# Access Compliance Report

## Public Rights-of-Way

### (Curb Ramps)

Intersection ID: 9561	Main Street: SELDON_DR	Cross Street: W_TRADE_ST	Location:	N
ADA ID: 1474EF37B51A	Ramp Type: PerpDiag	Initial Pass/Fail: Fail	Overall Compliance: No	Severity Score: 10

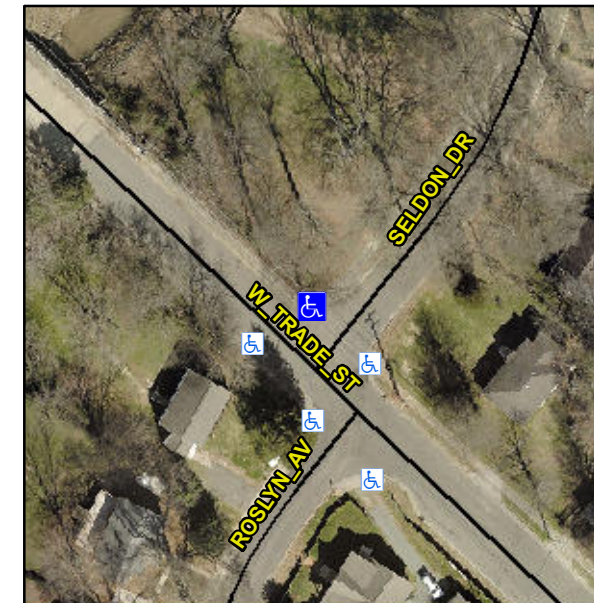
**Not Found, R304.5.1, R304.5.3**

Compliance	Description	Data	Compliance	Description	Data
N/A	Ramp Length (in)	53.5	Yes	Ramp Slope (%)	7.5
No	Ramp Width (in)	47.0	No	Ramp XSlope (%)	4.5
N/A	Flare Type LT	N/A	N/A	Flare Type RT	N/A
N/A	Flare Slope LT (%)	N/A	N/A	Flare Slope RT (%)	N/A
N/A	Flare Traversable LT?	N/A	N/A	Flare Traversable RT?	N/A
N/A	Landing Length (in)	N/A	N/A	DWS Provided?	N/A
N/A	Landing Width (in)	N/A	N/A	DWS Contrast?	N/A
N/A	Landing Slope (%)	N/A	N/A	DWS Length (in)	N/A
N/A	Landing X Slope (%)	N/A	N/A	DWS Full Width?	N/A
N/A	Landing Curb? (Y/N)	N/A	N/A	DWS Offset (in)	N/A
N/A	Shared Landing?	N/A			
N/A	Gutter Ponding?	N/A	N/A	Gutter Slope (%)	N/A
N/A	Gutter Lip Ht (in)	N/A	N/A	Gutter X Slope (%)	N/A
N/A	Painted X Walk1?	No	N/A	Painted X Walk2?	No
	X Walk 1 Direction	To SW		X Walk 2 Direction	To SE
N/A	X Walk 1 Width (in)	N/A	N/A	X Walk 2 Width (in)	N/A
	X Walk 1 Slope (%)	5.6		X Walk 2 Slope (%)	4.8
	X Walk 1 X Slope (%)	2.8		X Walk 2 X Slope (%)	5.9

**Remove & Replace Curb Ramp With Two New Directional Ramps or Equivalent.**
